## Section 1: LADACAN's comments on the Applicant's REP9-051 submission

## Section 2: LADACAN's further concerns regarding noise contour modelling

### Section 3: LADACAN's comments on the Applicant's REP9-055 submission

Above: Normal view showing the school building which bounds the garden to the south in the direction of aircraft transits. The resident has advised that this is a 3-storey building.

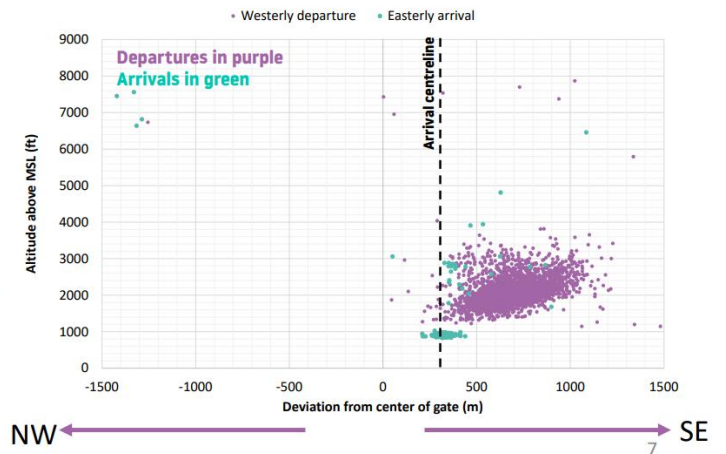
A 2m high mast looking across a 6.1m garden at 23° elevation would reach 8.5+12=21ft high, less than the 3-storey building wall.

The centre-of-swathe value of 23° is well below what the CAA considers reliable in noise measurement<sup>2</sup>. However, as the photographs show, the location is unsuitable for reliable aircraft noise monitoring in any case given the proximity of the adjacent tall building and vegetation in line of sight to the flights.

A 2m high mast looking across a 6.1m garden at 34° elevation would reach 13.5+12=26ft high, less than the 3-storey building wall.

Furthermore, as in the case of arrivals, it would appear that the majority of flight transits would pass behind the adjacent building and therefore be subject to further indeterminate attenuation and/or scattering.

**LTN\_BG**

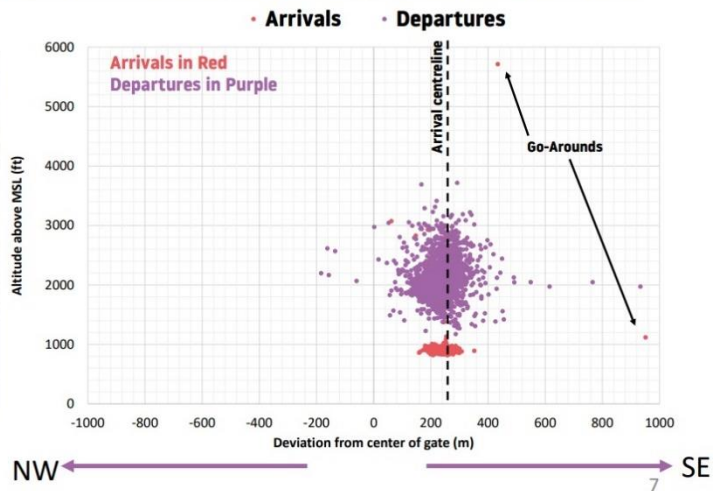
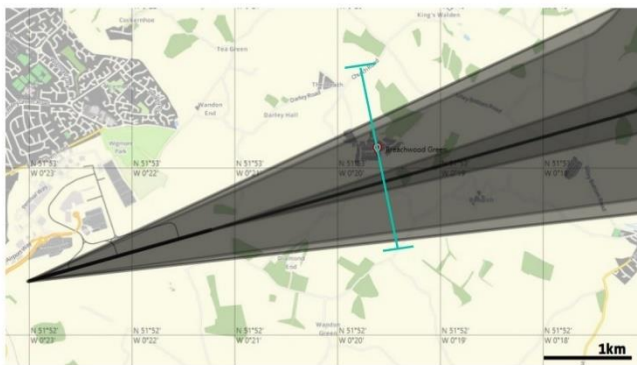
A resident of Breachwood Green who lives close to where the 2019 monitoring was performed has advised LADACAN of the precise location, which enables a similar analysis to be conducted.

As for LTN\_SLTN, the centre-of-swathe elevation angle of 27° for arrivals is well below what the CAA considers is necessary for reliable noise measurement. The vast majority of arrivals noise measurements would be affected by lateral attenuation of varying degrees.

Departures passing LTN\_BG are less affected unless at the southern edge of the swathe and/or at low altitudes. Nevertheless, the vast majority is below 60°, the elevation angle above which attenuation due to distance can be ignored.

In the case of the 2019 Breachwood Green monitoring, a clear line of sight is available but the angle of elevation of arrivals is below the CAA threshold for 3dB distance attenuation and in more than half of cases also below the 35° threshold at which lateral attenuation and scattering increases rapidly.
